BLAISE AD HAZOP

RMD-02-004

An interface HAZOP study was undertaken at BioConstruct's offices at Stockton-on-Tees, Teesside on 3rd June 2019, commencing on 4th June and being completed on 9th July, on the design of the proposed Anaerobic Digestion Facility for Crofthead.

This report details the findings of the HAZOP Study. The drawings used in the HAZOP study are found in the Drawings Section of this report and are based upon the following P&IDs:

This drawing is the intellectual property of PENTAIR and may not be shown to third parties without our permission.

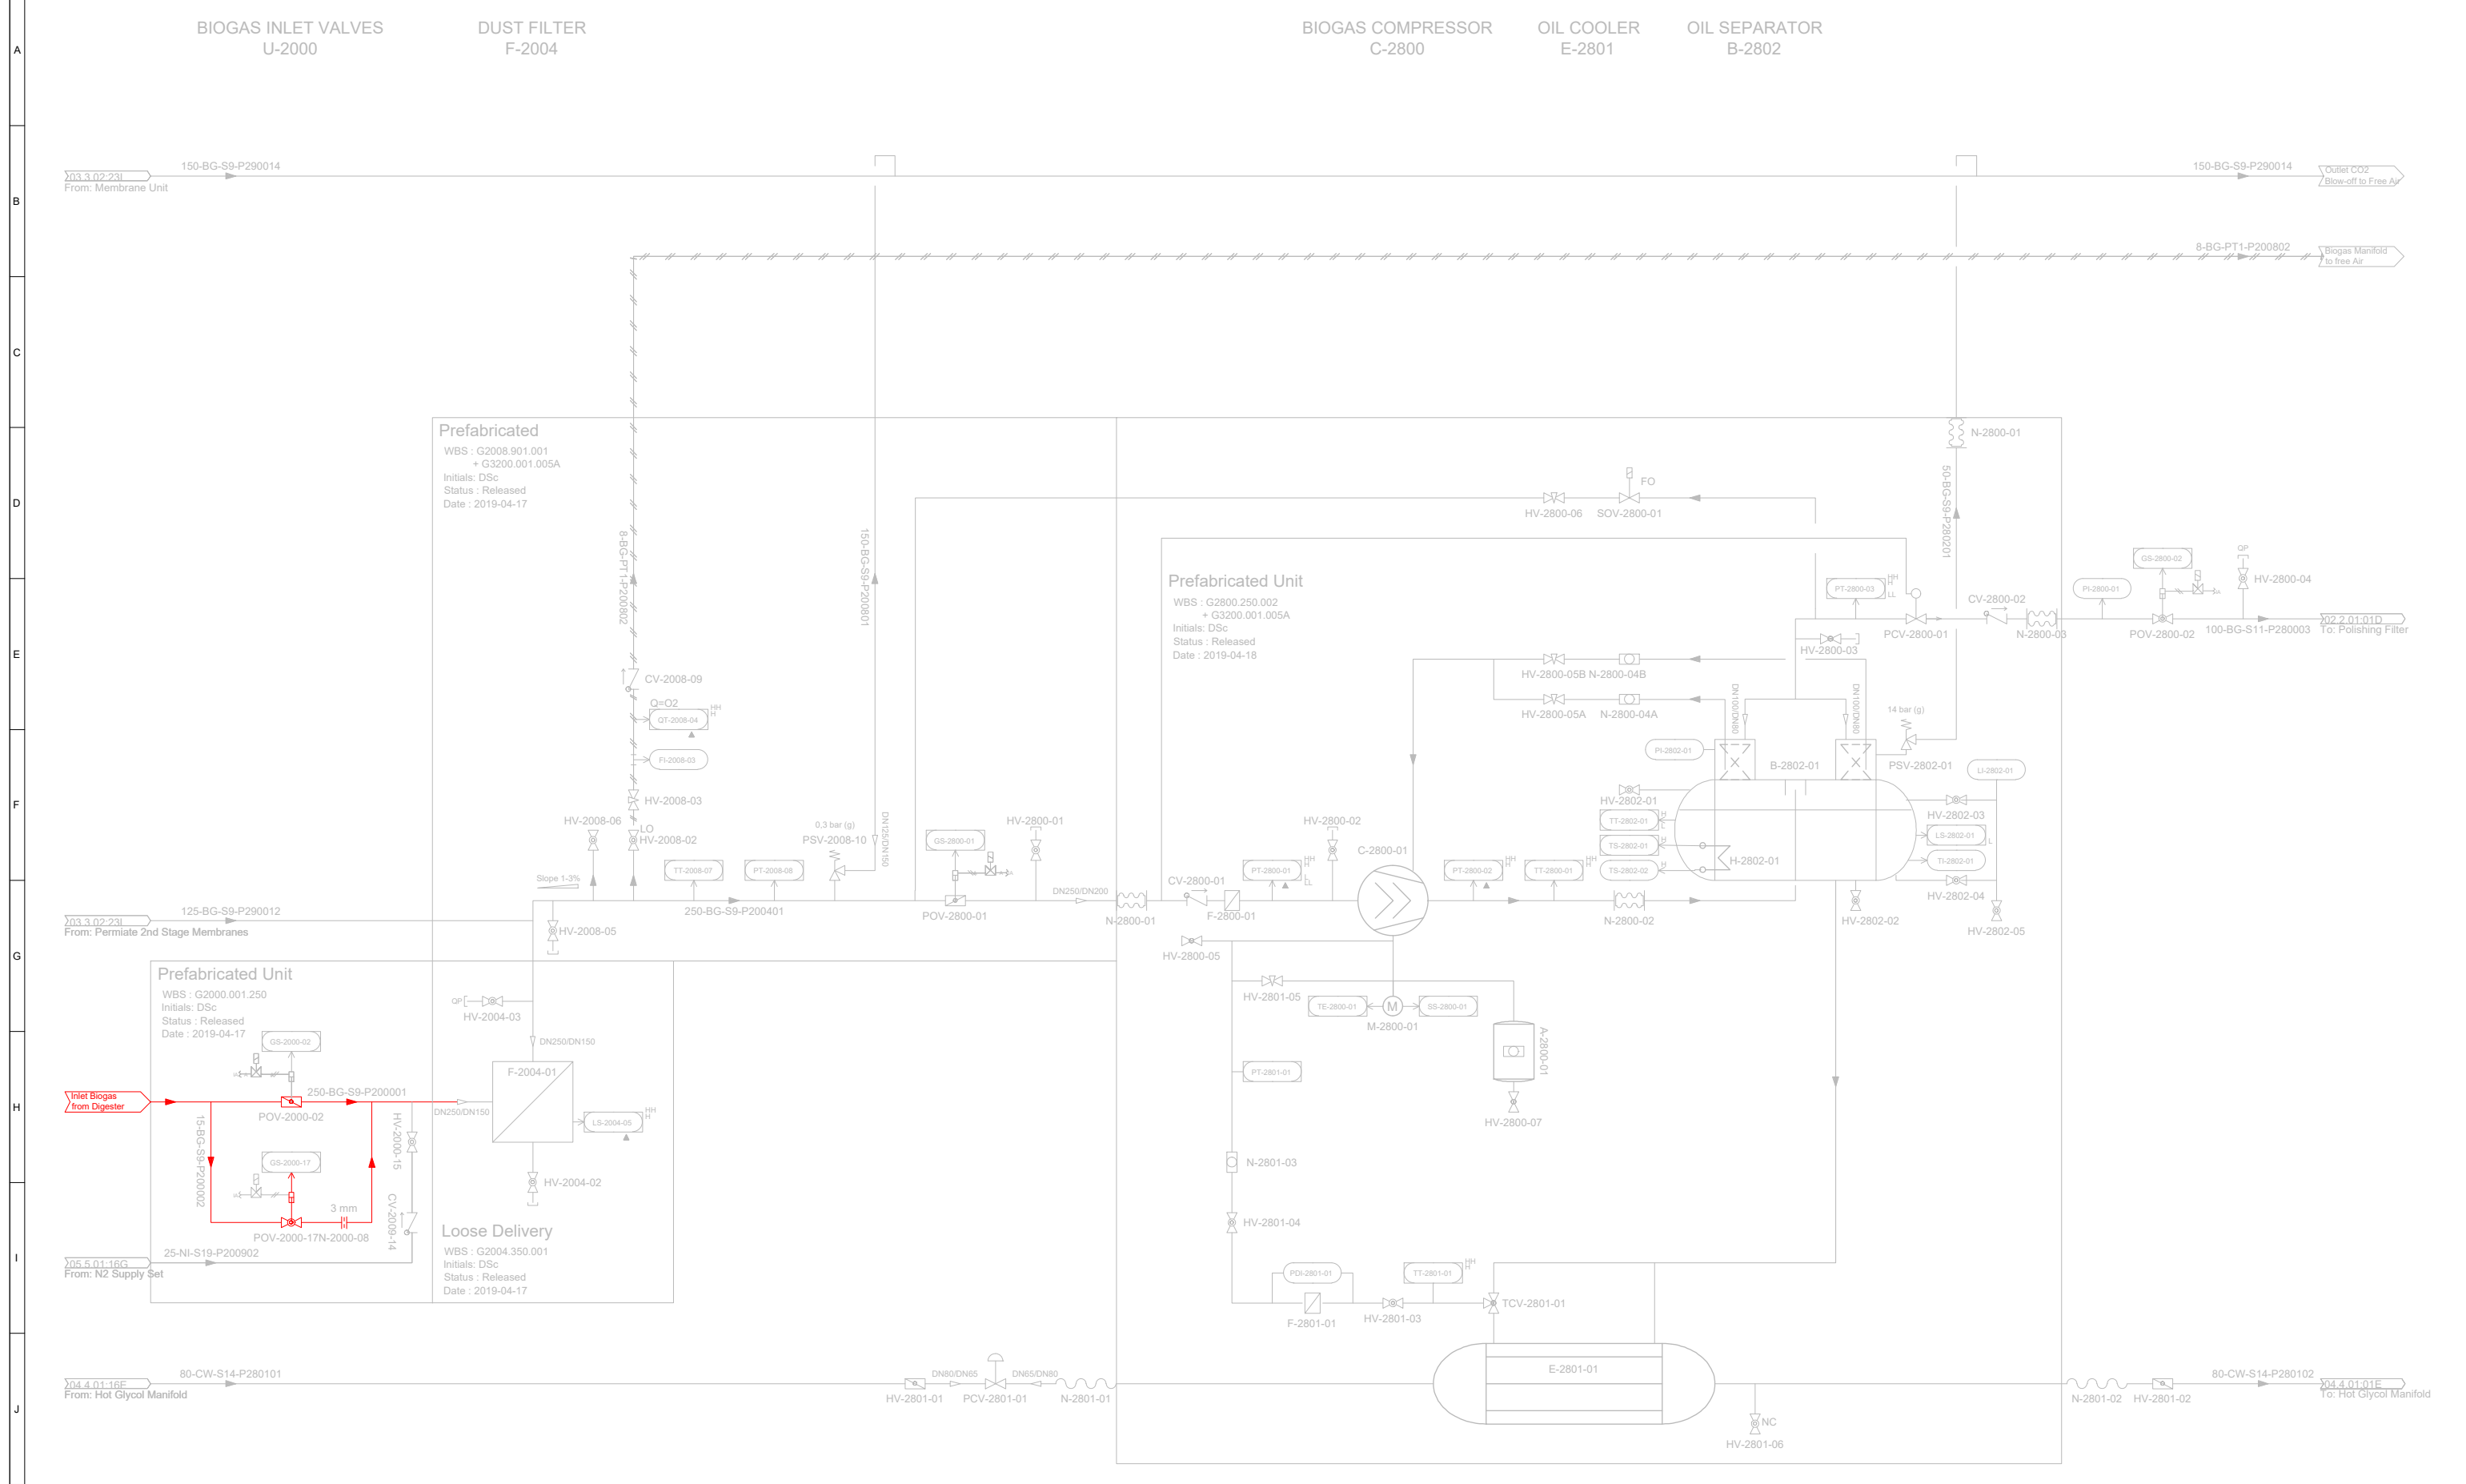
| ID/No. | Deviation | | No. | Possible Causes | Consequence | Safeguards | No. | Actions Required | Action Allocated to |
|--------|----------------|-----------|-------|--|--|--|---------|---|----------------------------|
| 1.1 | No | Flow | 1.1.1 | No flow into the BUU Poor biogas quality | <ul style="list-style-type: none"> Poor gas quality to Pentair unit potential for out of spec biomethane failure of GSMR specifications reject from GEU | <ul style="list-style-type: none"> Biogas analysis within AD facility will identify out of spec biogas feed to Pentair and will prevent feed to BUU - Pentair take BioConstruct signals and determine biogas quality Methane measurement within Pentair unit to ensure correct quality feed to GEU | | | |
| | | | 1.1.2 | Manual valve GT5G Y300 closed when should be open normally open operator / commissioning / maintenance error | <ul style="list-style-type: none"> Valve shut prior to start-up of Pentair unit results in low flow signal and inability to start the Pentair unit Valve closed during operation potential catastrophic failure of compressors increased fire and explosion risk | <ul style="list-style-type: none"> Operator training Pre-commissioning and post maintenance checks Secure site Low pressure alarm shuts down Pentair unit compressors Overpressure relief within Pentair unit through PSV-2802-01 (14barg) | | | |
| 1.2 | No | Flow | 1.2.1 | No flow to GEU | <ul style="list-style-type: none"> No flow of biomethane to the GEU - no injection to grid inefficient operation Potential overpressure of BUU, increased fire and explosion risk | <ul style="list-style-type: none"> Operator training Pre-commissioning and post maintenance checks Overpressure relief within the BUU Alarm signals from the BUU ROV will stay open Ability to interrogate the Pentair through the BioConstruct dial in system | | | |
| | | | 1.2.2 | Manual valve GT6G Y300 closed when should be open normally open operator / maintenance / commissioning error | | | | | |
| 1.4 | More | Pressure | 1.4.1 | High inlet pressure from BUU | <ul style="list-style-type: none"> Potential overpressure of GUU - increased fire and explosion risk | <ul style="list-style-type: none"> GEU pipework and system designed to 16 bar pressure Interconnecting pipework between BEU and GEU designed to 16 bar pressure Overpressure relief in BUU 14bar Pressure regulator PCV-2904-01 regulates inlet pressure to GEU to approximately 7.5 - 8.5barg | | | |
| 1.5 | No | Signal | 1.5.1 | Loss of signal from BUU to GEU | <ul style="list-style-type: none"> Loss of signal will result in shutdown of GEU if operational if not operational GEU sits in readiness | <ul style="list-style-type: none"> Reciprocal watch dog on signals which will alarm on loss of signal Shutdown of GEU will result in controlled shutdown of BEU | | | |
| | | | 1.5.2 | Loss of signal from GEU to BUU | <ul style="list-style-type: none"> Loss of signal will result in controlled shutdown of BEU resulting in controlled shutdown of GEU | <ul style="list-style-type: none"> Reciprocal watch dog on signals which will alarm on loss of signal Shutdown of BEU will result in controlled shutdown of GEU | | | |

| ID/No. | Deviation | | No. | Possible Causes | Consequence | Safeguards | No. | Actions Required | Action Allocated to |
|--------|----------------|-----------|-------|--|--|--|---------|---|----------------------------|
| 1.3 | General Action | | | | | | 1.3.2.1 | Ensure design of pipework between BUU and GUU is corrects | DNG, Elster & BioConstruct |
